RECEIPT DATE: 7-29-19 **ONSITE SEWAGE DISPOSAL SYSTEM** P 965575

RE: 2385 Rt. 97
Cooksville, MD 21723
"Septic Plan Comments"

**SEPTIC SYSTEM INSTALLATION SITE PLAN**  
**2385 MARYLAND ROUTE 97**  
 ZONED: RC-DEO  
 TAX MAP 14 GRID 11 PARCEL 253  
 FOURTH ELECTION DISTRICT HOWARD COUNTY, MARYLAND  
 SCALE: 1" = 40' DATE: OCTOBER, 2018  
 SHEET 1 OF 1

**SEPTIC SYSTEM INSTALLATION SITE PLAN**  
**2385 MARYLAND ROUTE 97**  
 ZONED: RC-DEO  
 TAX MAP 14 GRID 11 PARCEL 253  
 FOURTH ELECTION DISTRICT HOWARD COUNTY, MARYLAND  
 SCALE: 1"=40' DATE: NOVEMBER, 2018  
 SHEET 1 OF 1

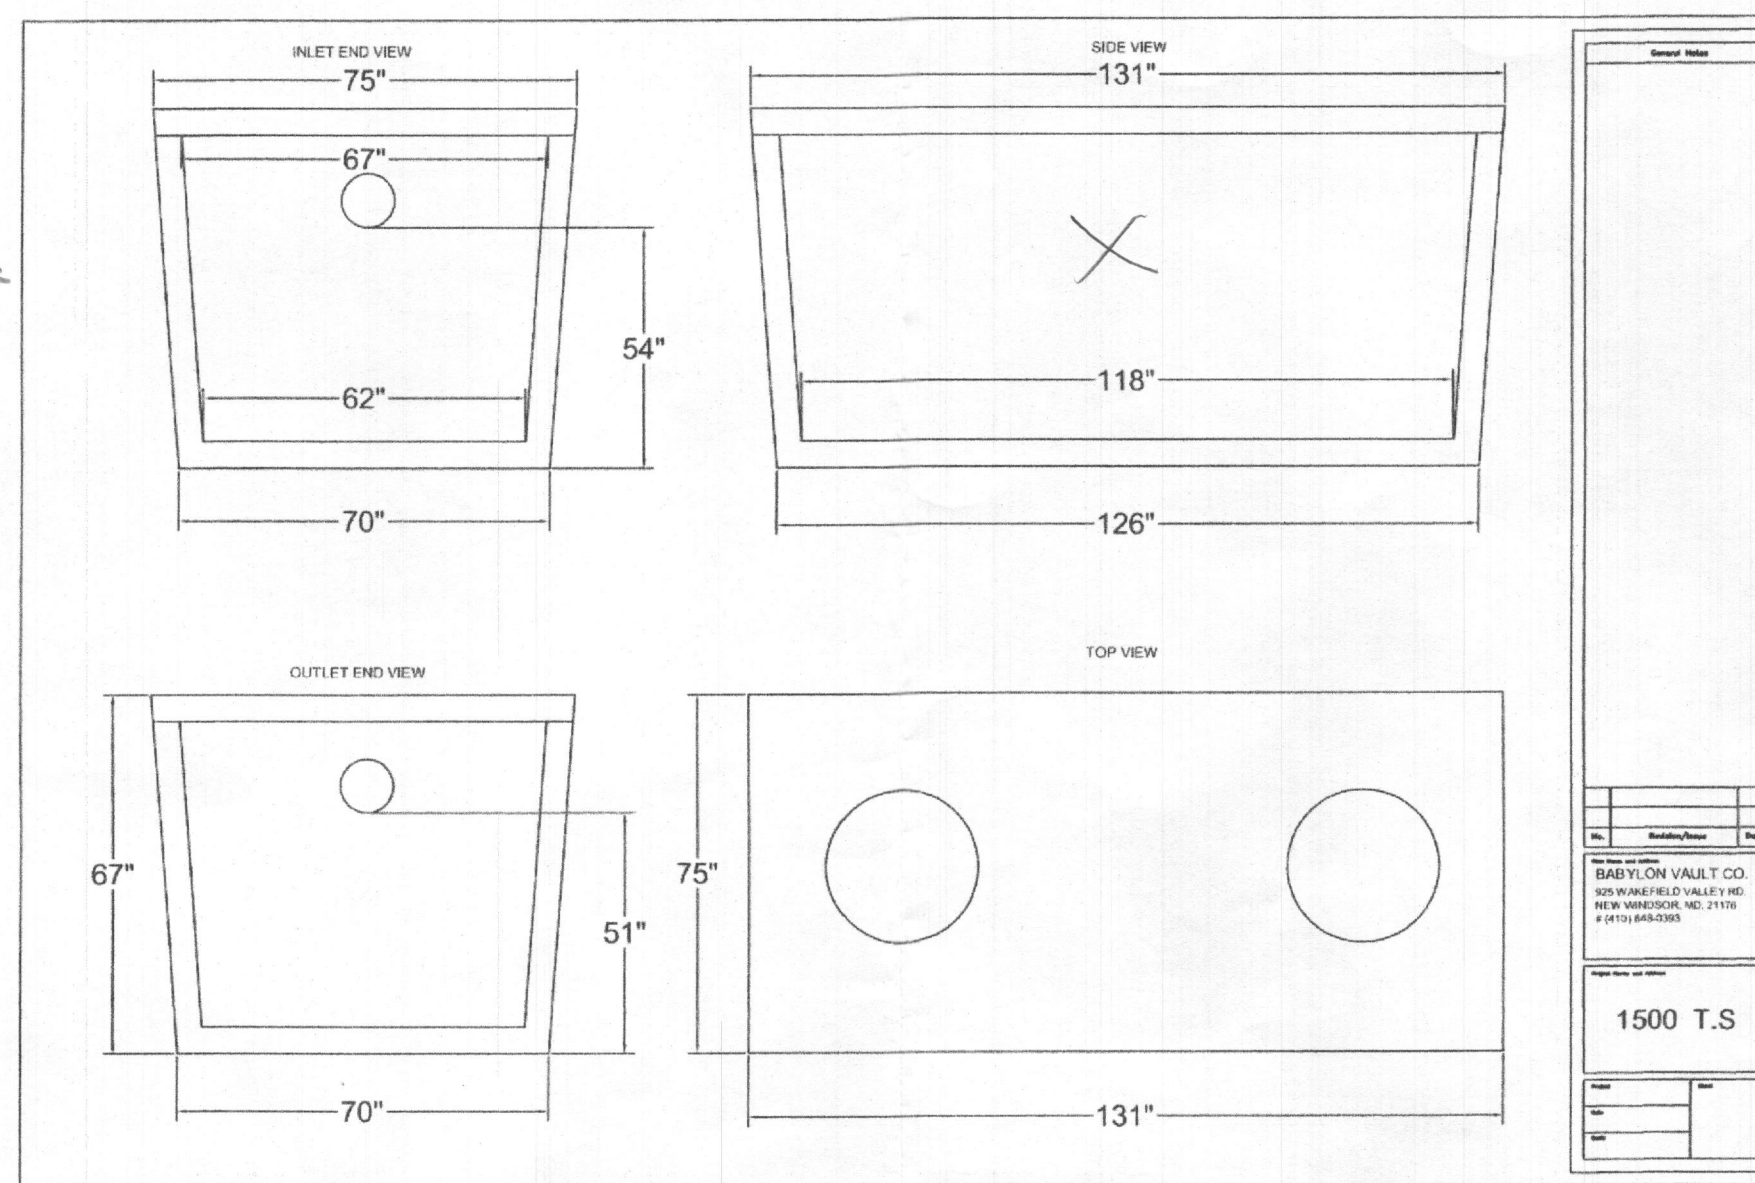
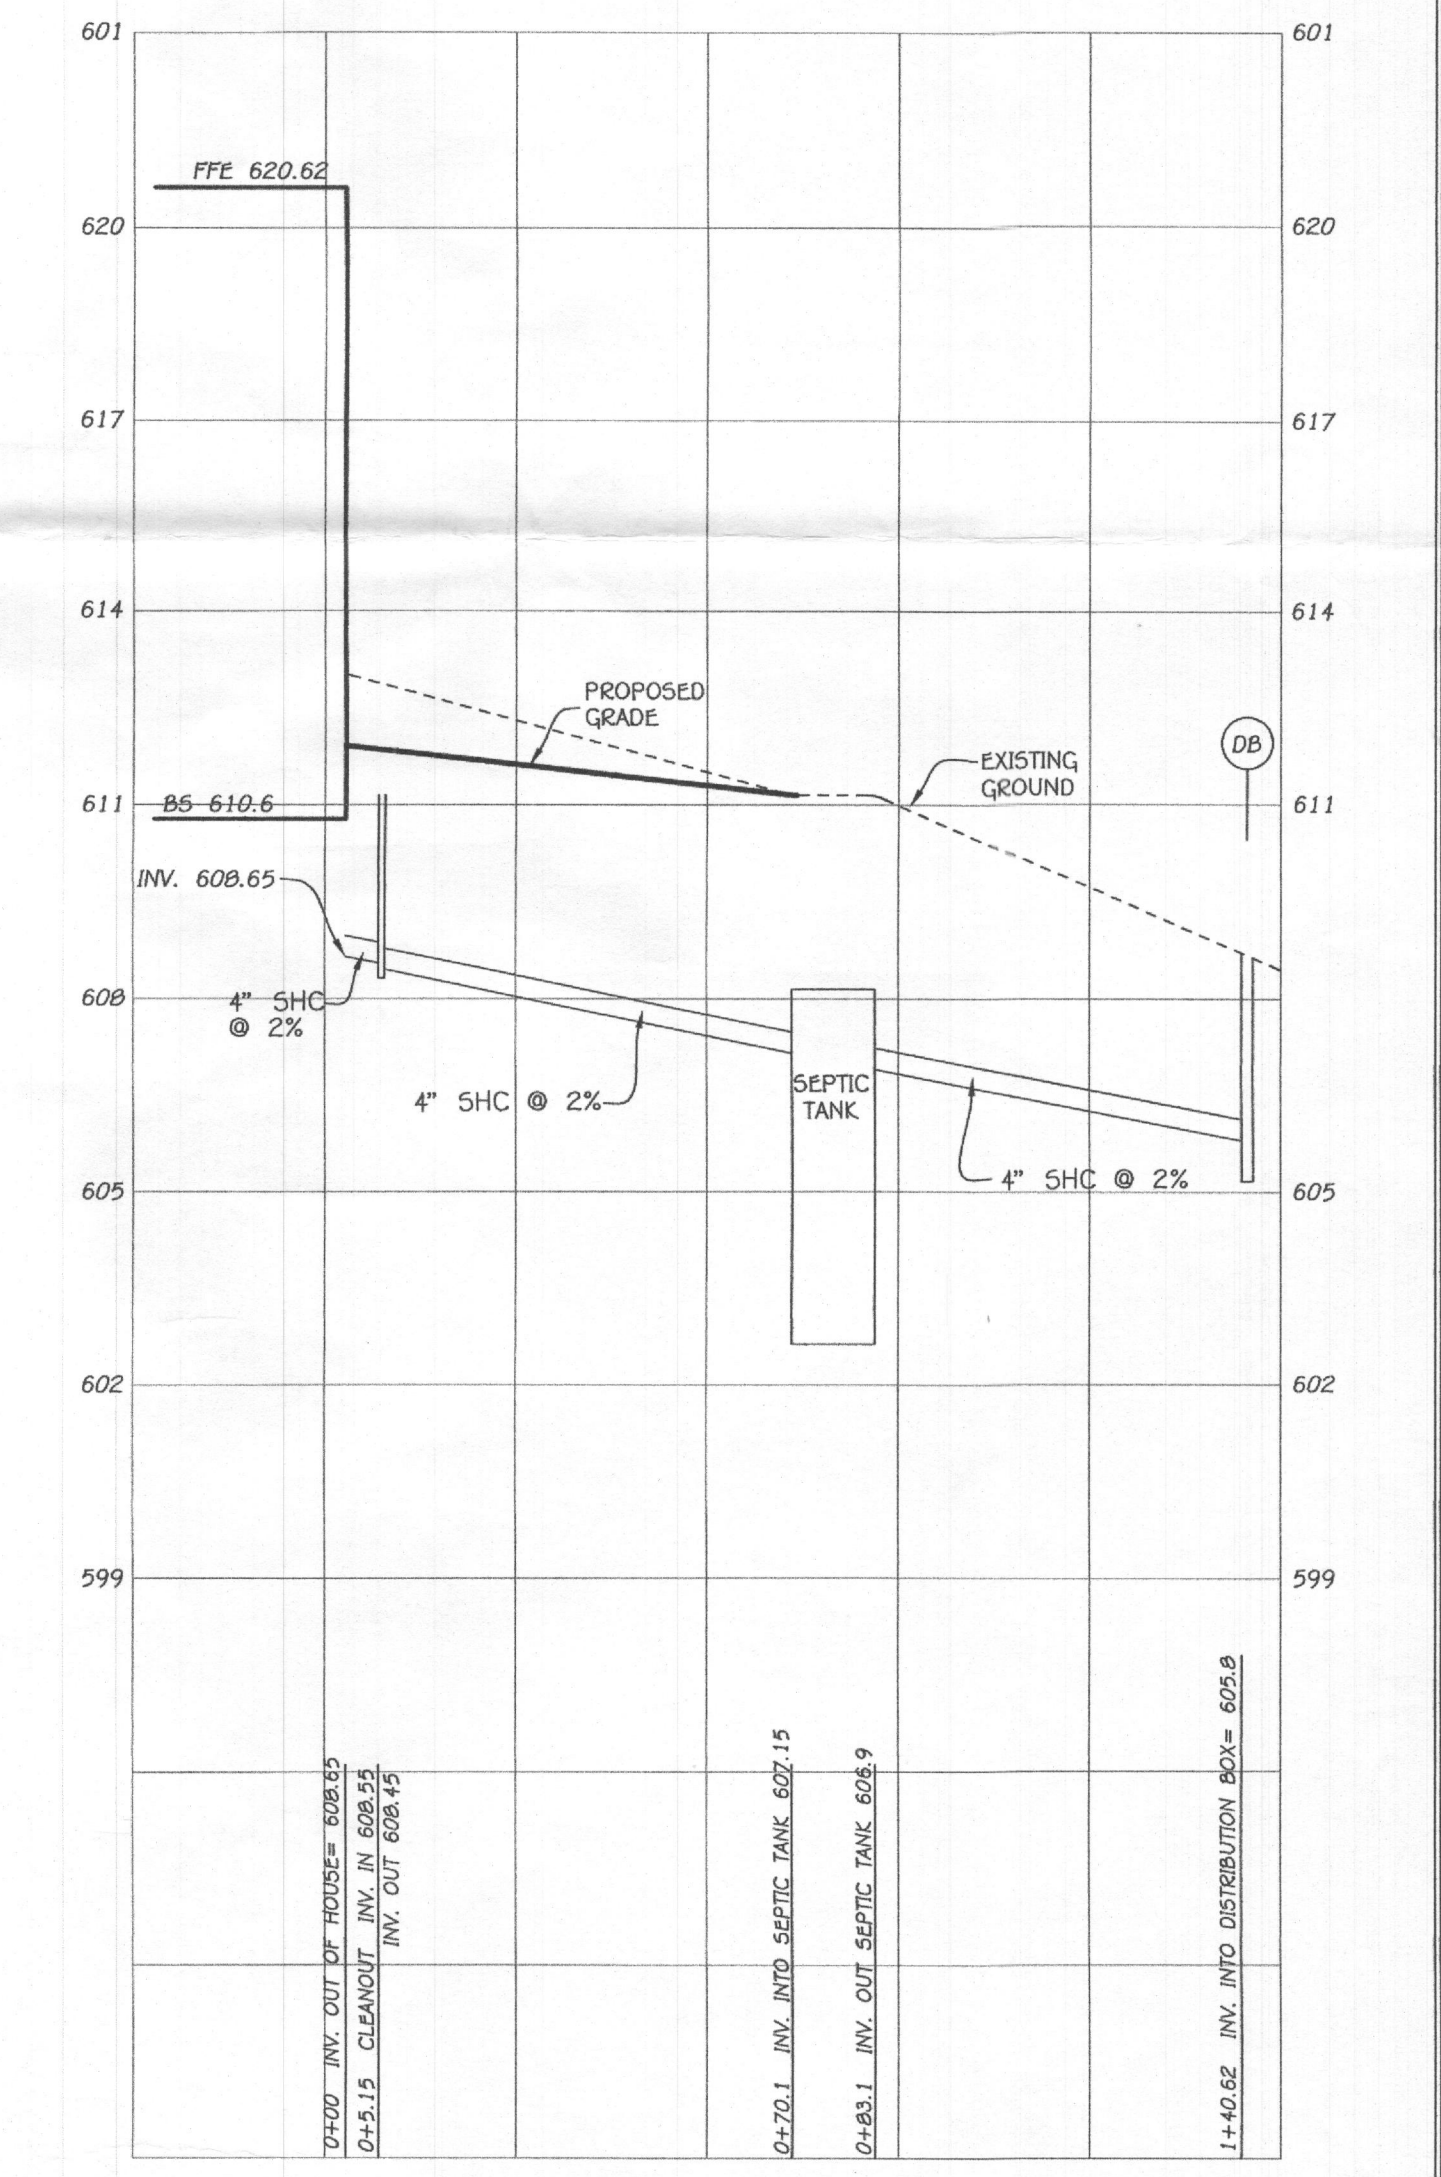
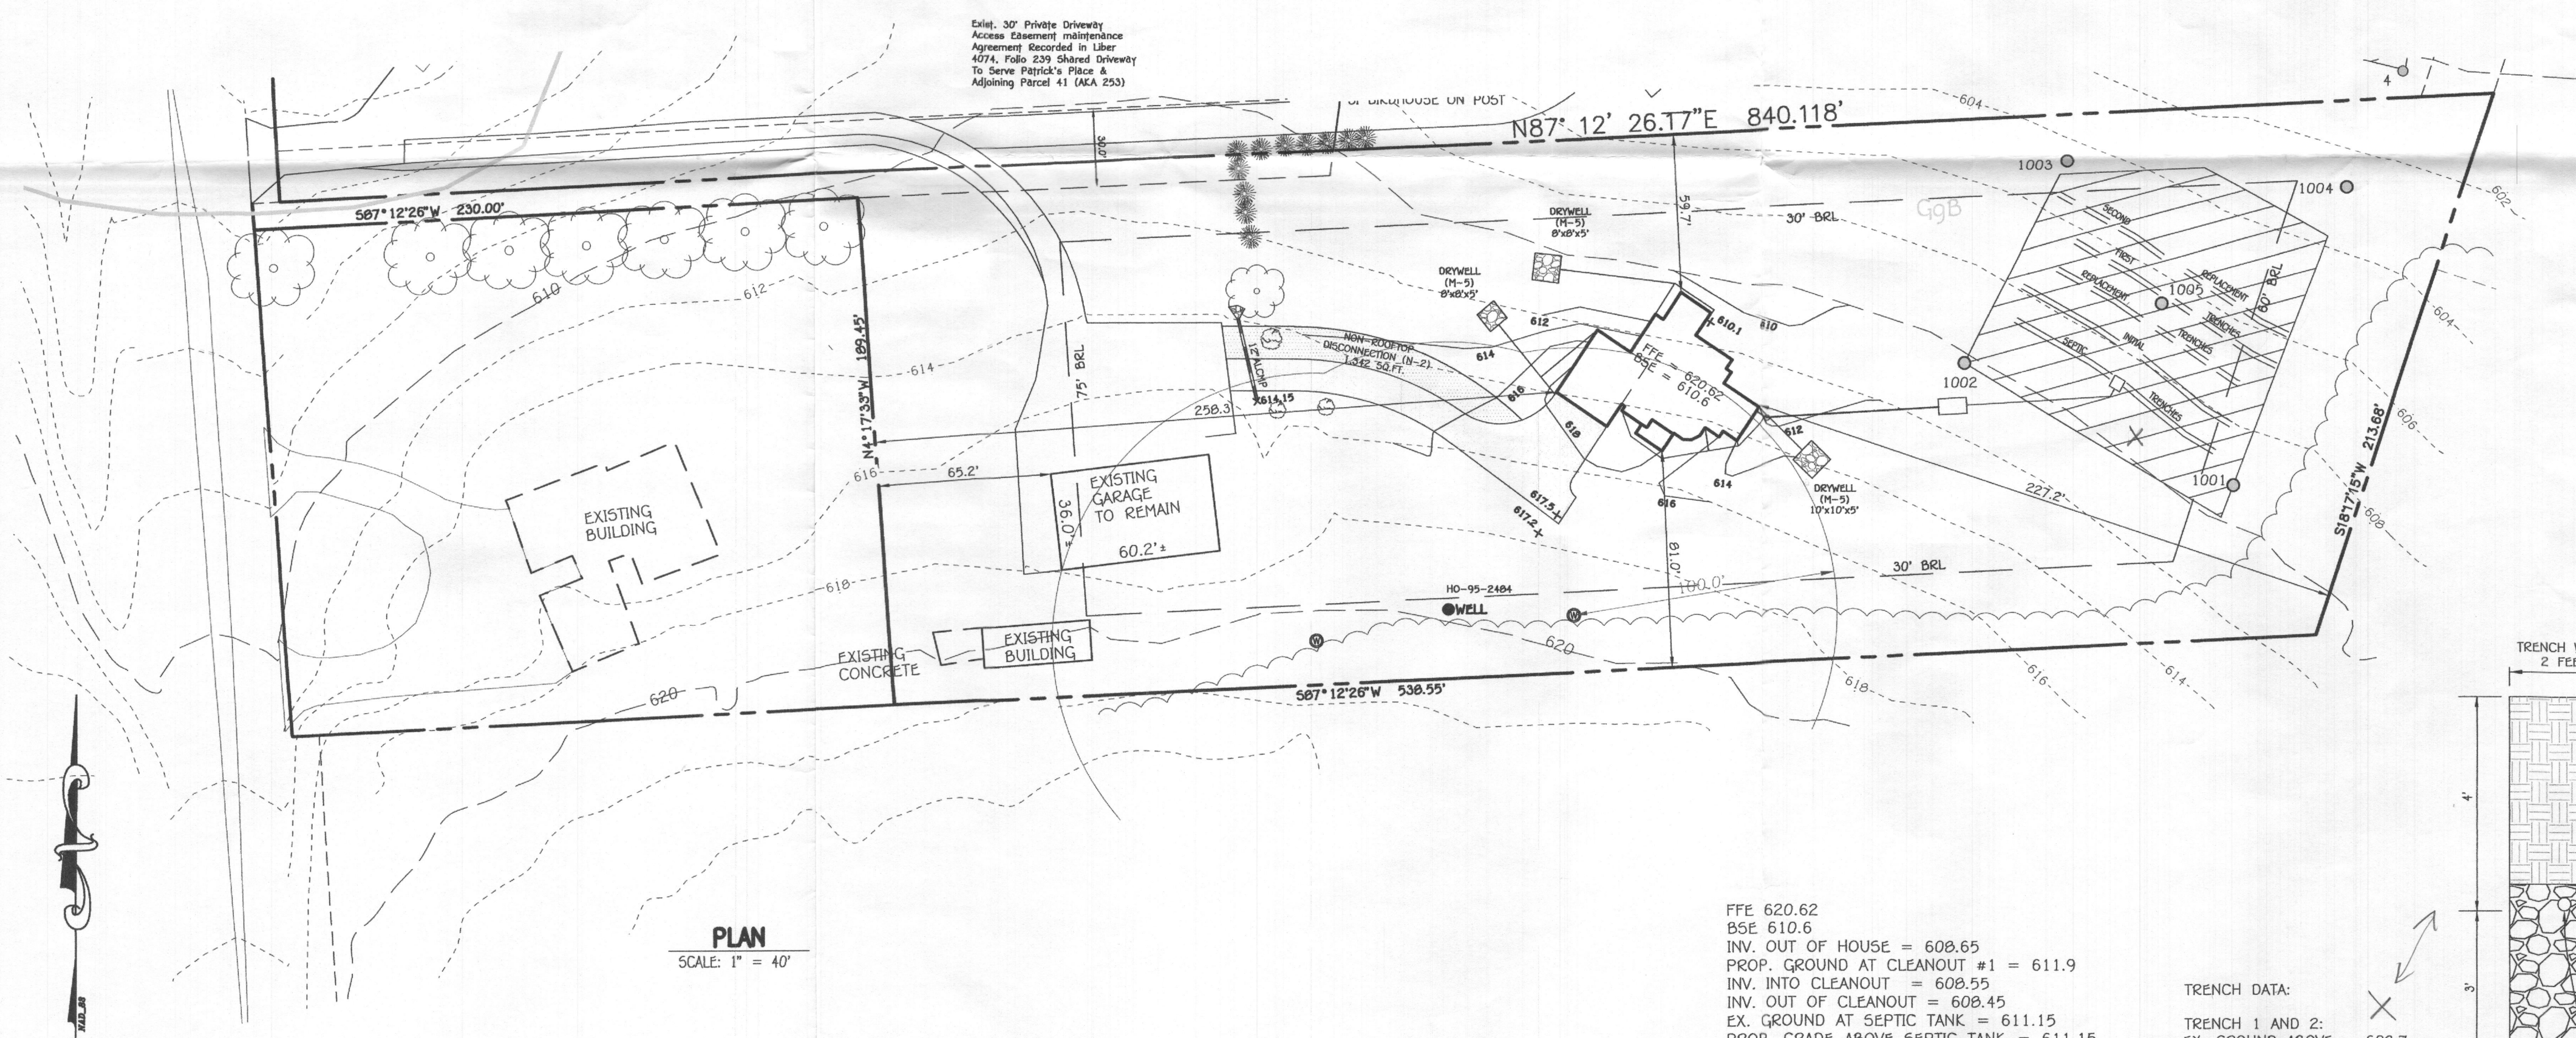
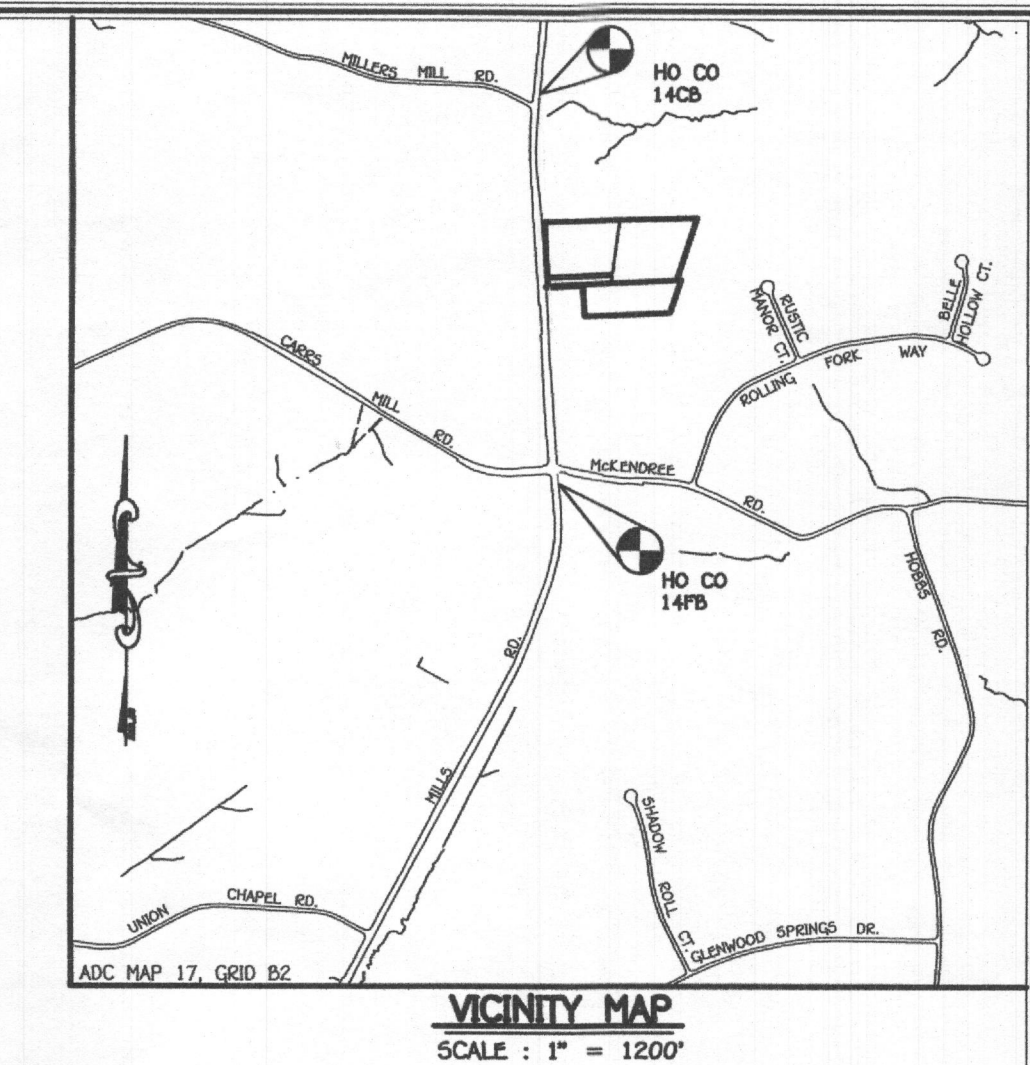
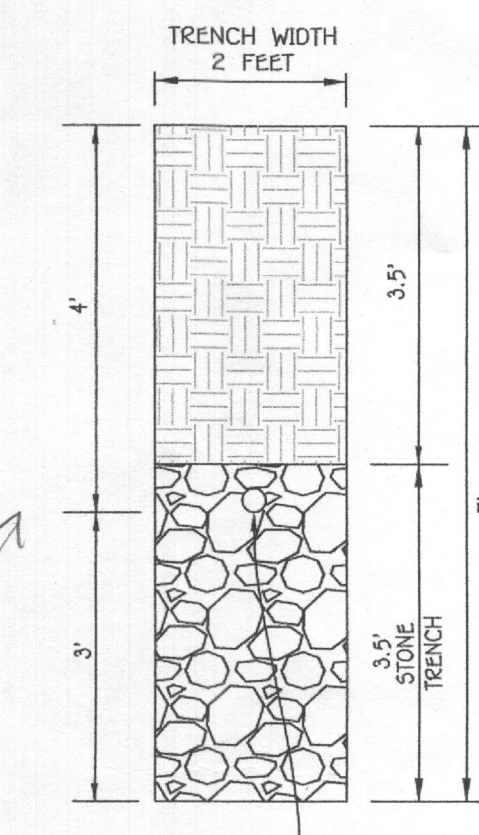
- x • Septic tank must be a two chamber tank. Center wall must have a slot 2 inches in height and 4 feet wide for the effluent to flow through. This center wall should split the tank in to a 2/3<sup>ds</sup> section and a 1/3<sup>rd</sup> section.
- x • Clearly label trenches as to which are the initial and which are replacements. Whole trenches should be shown as whole trenches. Showing sections of a trench that is actually whole will be confusing.
- x • Show the sqft of the SDA.
- x • Make sure each section of the septic plan (Initial Trench Detail, 2<sup>nd</sup> Replacement System and Trench Data) corresponds with one another.

Included trenches needing to be shifted to top of SDA.
